Access Compliance Report

Public Rights-of-Way

(Curb Ramps)

Intersection ID: 47300	Main Street: LELA_AV	Cross Street: HURSTON_CR	Location: W
ADA ID: E7F2F38FE330	Ramp Type: BlendTrans1	Initial Pass/Fail: Fail	Overall Compliance: No
Codes/Mitigation Info/Possible Solution		Field Measurements/Component Compliance	
Severity Score: 8.75

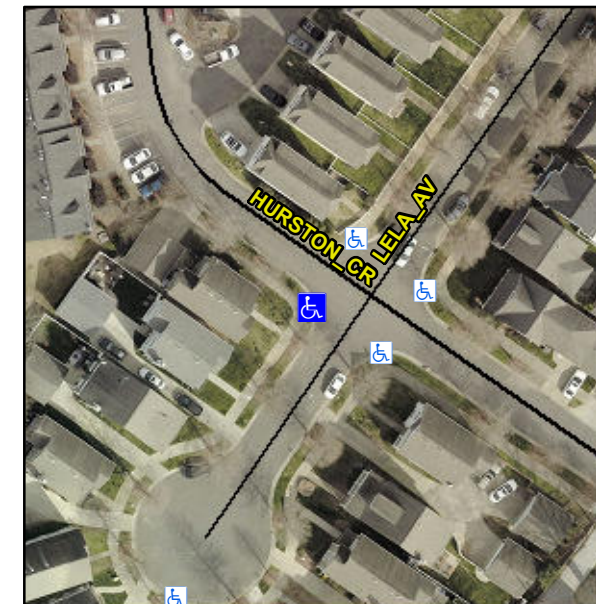
Not Found, R304.5.1

Compliance	Description	Data	Compliance	Description	Data
N/A	Ramp Length (in)	47.5	Yes	BlendTrans Slope (%)	3.4
No	Ramp Width (in)	39.0	Yes	BlendTrans XSlope (%)	1.0
N/A	Flare Type LT	N/A	N/A	Flare Type RT	N/A
N/A	Flare Slope LT (%)	N/A	N/A	Flare Slope RT (%)	N/A
N/A	Flare Traversable LT?	N/A	N/A	Flare Traversable RT?	N/A
N/A	Landing Length (in)	N/A	N/A	DWS Provided?	N/A
N/A	Landing Width (in)	N/A	N/A	DWS Contrast?	N/A
N/A	Landing Slope (%)	N/A	N/A	DWS Length (in)	N/A
N/A	Landing X Slope (%)	N/A	N/A	DWS Full Width?	N/A
N/A	Landing Curb? (Y/N)	N/A	N/A	DWS Offset (in)	N/A
N/A	Shared Landing?	N/A			
N/A	Gutter Ponding?	N/A	N/A	Gutter Slope (%)	N/A
N/A	Gutter Lip Ht (in)	N/A	N/A	Gutter X Slope (%)	N/A
N/A	Painted X Walk1?	No	N/A	Painted X Walk2?	No
	X Walk 1 Direction	To SE		X Walk 2 Direction	To NE
	X Walk 1 Width (in)	N/A		X Walk 2 Width (in)	N/A
	X Walk 1 Slope (%)	2.2		X Walk 2 Slope (%)	1.0
	X Walk 1 X Slope (%)	3.7		X Walk 2 X Slope (%)	2.0

N/A	Ramp inside XWalk1?	N/A	N/A	Ramp inside XWalk2?	N/A
	Road Slope (%)	1.3		Clear Space?	N/A
	Road X Slope (%)	0.1	N/A	Clear Space to XWalk (in)	N/A
N/A	Any Obstructions?	N/A	N/A	Storm Grate/Utility Hazard?	N/A
	Obstruction Type			Storm Grate/Utility Type	
		N/A			N/A
			Yes	Surface Condition? (G/P)	Good
			No	Curb Slope (%)	12.1

Remove & Replace Curb Ramp With Two New Directional Ramps or Equivalent.
